July 3, 2018

RE: Site Plan and Traffic Review for "Edgewater," City of Beacon, NY;  
CM Project #117-083.1

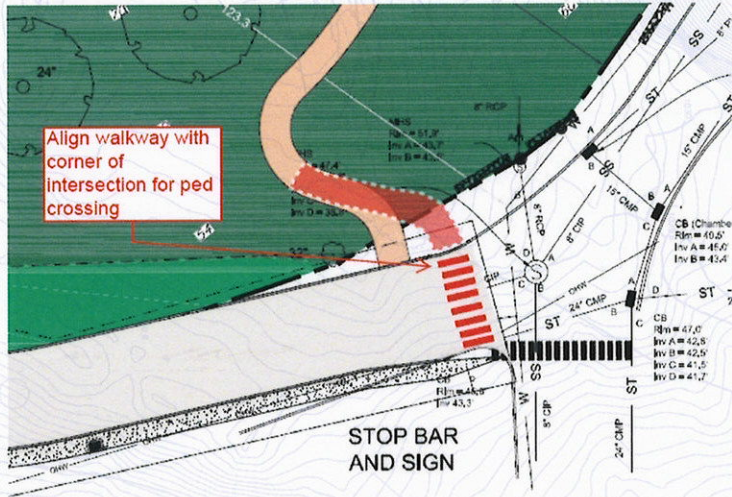
1. We concur with the traffic assessment and the findings that the revised project will generate fewer trips than originally studied and support reaffirming a negative declaration.
2. With regards to the revised site plan, the walkways on the backside of the buildings should restrict resident access with removable bollards that will still allow emergency or maintenance access. The walkway at Bank Street/Branch Street should align to provide a pedestrian crossing from one corner to the other. See site plan excerpts below.
